PRODUCT ADVISORY

Data Sheet Specification Correction for the Listed Intersil ISL4270* QFN Packaged Products

**Refer to:
PA10061**

Subject: **Data Sheet Specification Correction for the Listed Intersil ISL4270*
QFN Packaged Products**

Incorrect POD – PA10061

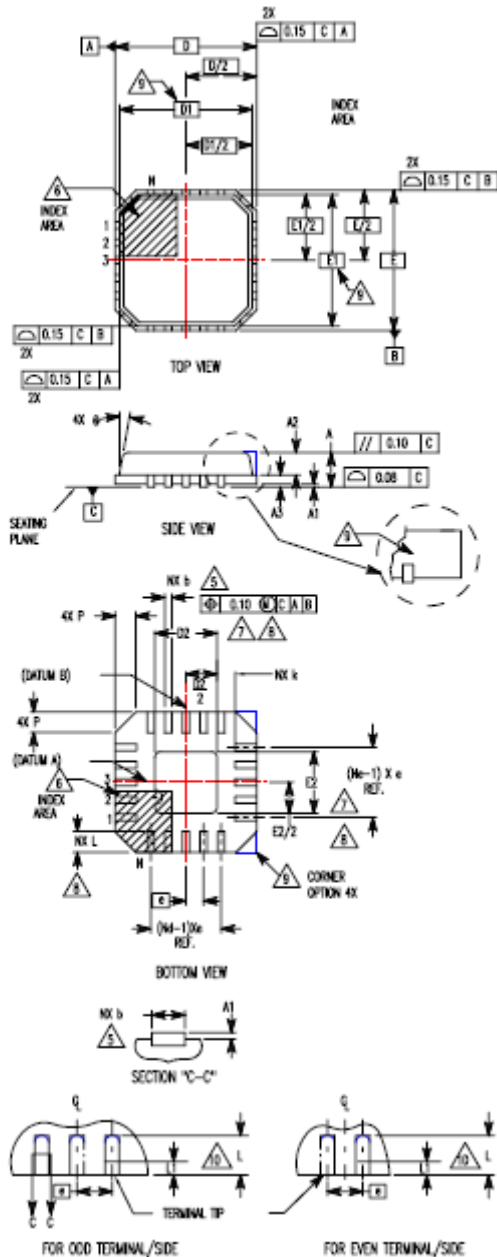
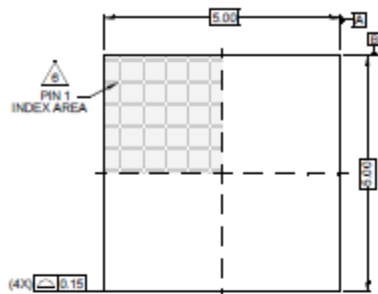
This advisory is to inform you that Intersil has made corrections to the POD (Package Outline Drawing) referenced in the data sheet specification for the listed Intersil ISL4270* QFN (Quad Flat No-Lead) packaged products. The updates to the POD correct the exposed pad dimensions and incorporate Intersil's new POD format. There have been no changes made to the package or product itself. The updated data sheet incorporating the corrected POD is available on the Intersil web site at <http://www.intersil.com/data/fn/fn6041.pdf>.
